6 March 2013

Re: Frazier Street Submittal – Design Review Comments
Roswell, Georgia

Jackie, this is to submit review comments regarding the Frazier Street multifamily submittal. You and other city staff have requested that we review the submittal for conformance with the spirit and intent of the Ordinance and Design Guidelines as well as for conformance with the requirements found in each document. For clarity these comments are grouped into the categories 'General', 'Site Design', and Architectural Design'.

Encl: Sketch Site Plan Recommendation, March 3, 2013

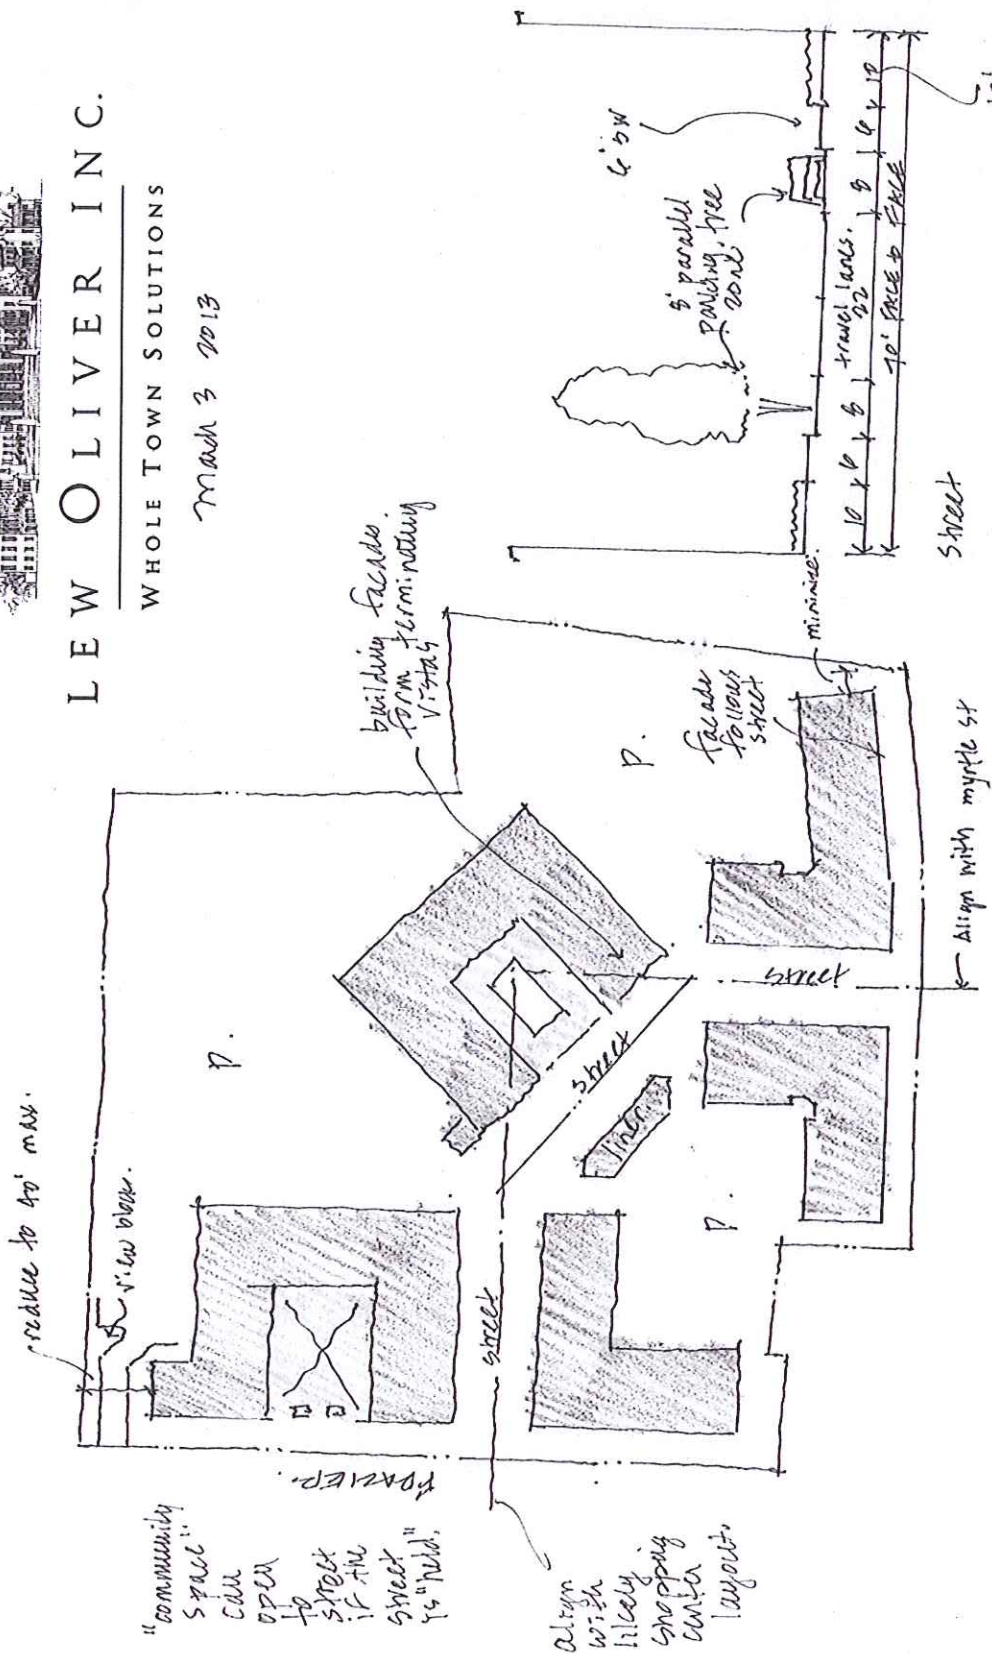
- The submitted site plan meets the minimum parking requirement in the Ordinance however the submitted site plan is much more about the automobile than the City envisions.
- A sketch drawn by Lew Oliver of Lew Oliver, Inc. is attached as an exhibit to recommend an alternative site plan that will improve the pedestrian experience and reduce the visual impact

of the automobile. It includes an internal street with street parking and street trees. The internal street varies the circulation experience within the project. It is no longer simply a set of parking trays and drives. (See Ordinance pg. 1, 12.4.1 Implementation, 2nd bullet, pg. 2 12.4.2 Purpose and Intent #4, and pg. 61 Streetscape Section.) The attached site sketch also calls for alignment of entry points with Myrtle Street and the new retail center layout.

- Design the parking areas as groves and yards vs. suburban styled bulb outs and "islands".
- If the improved site plan requires a change to the minimum parking requirement, the City Planner should consider allowing the 20% decrease consideration found in Article 17 of the Zoning Ordinance. This will facilitate site planning flexibility. This project is fortunate to have an adjacent property under the same ownership that holds considerable parking sharing potential for occasional resident overflow.
